Westinghouse Electric Company
Nuclear Power Plants
P.O. Box 355
Pittsburgh, Pennsylvania 15230-0355
USA

SUBJECT: Transmittal of Responses to AP1000 DSER Open Items

DCP/NRC1617
Docket No. 52-006

SUBJECT: Transmittal of Westinghouse Proprietary Class 2 Documents Related to
AP1000 Design Certification Review Draft Safety Evaluation Report (DSER)
Open Item Response

Figure 15.6.5.4C-27

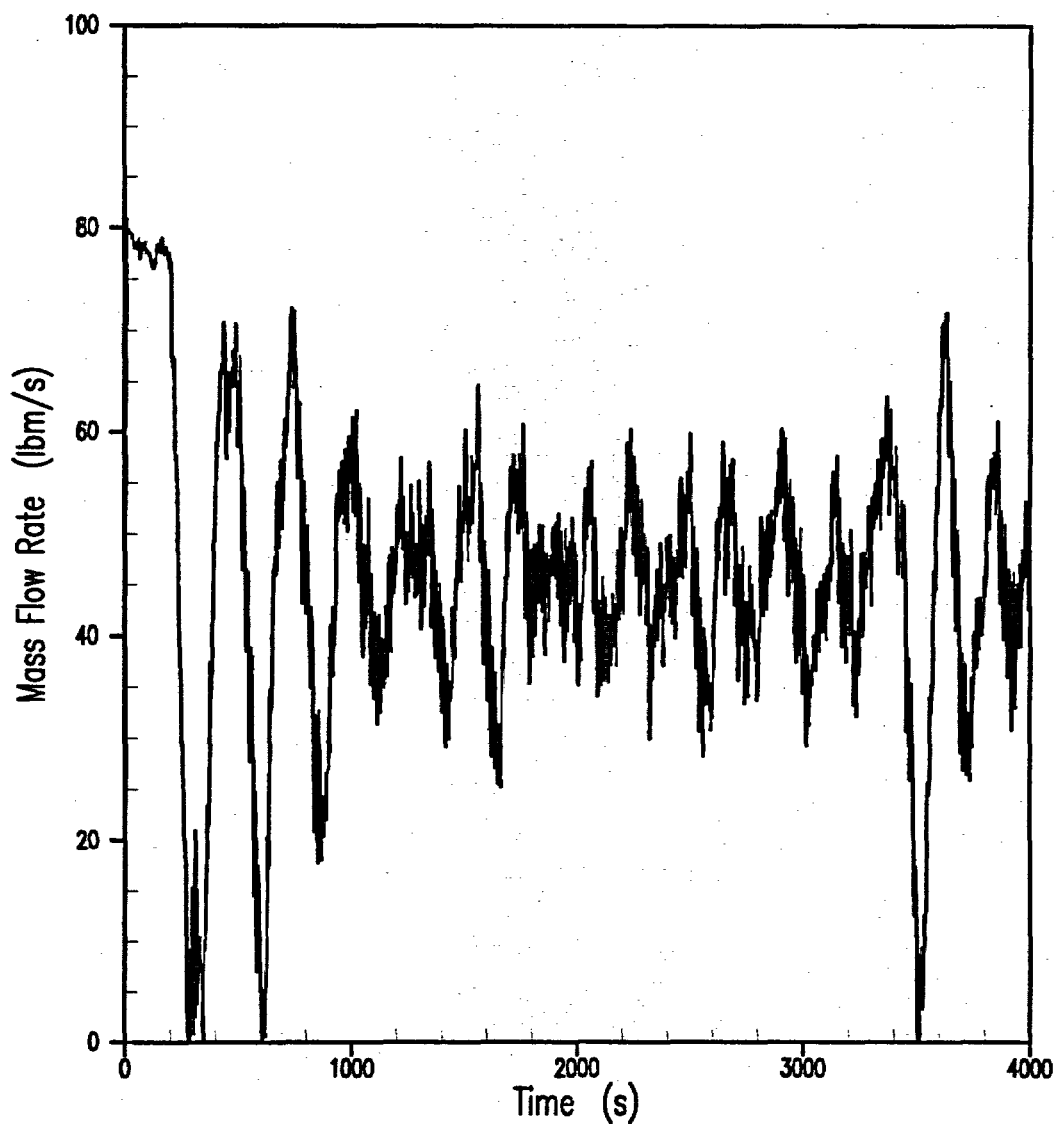
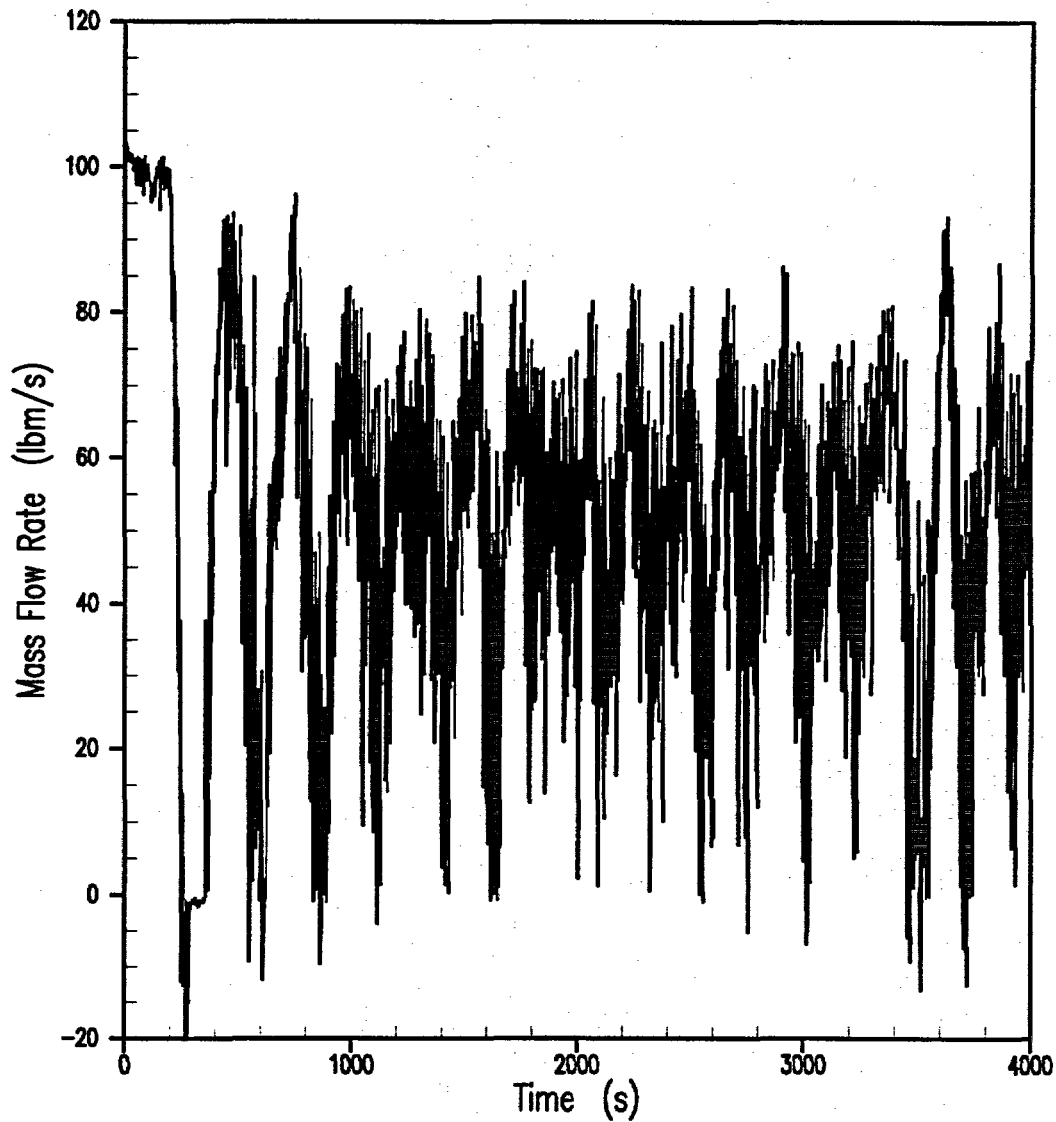
The pressure in the upper plenum is shown in Figure 15.6.5.4C-25. The upper plenum pressurization, which occurs periodically, is due to the ADS Stage 4 water discharge. The collapsed liquid level in the hot leg of the pressurizer loop varies between 0-01.0 feet to 2-02.2 feet, as shown in Figure 15.6.5.4C-19. Injection rates through the DVI lines into the vessel are presented in Figures 15.6.5.4C-27 and -28.
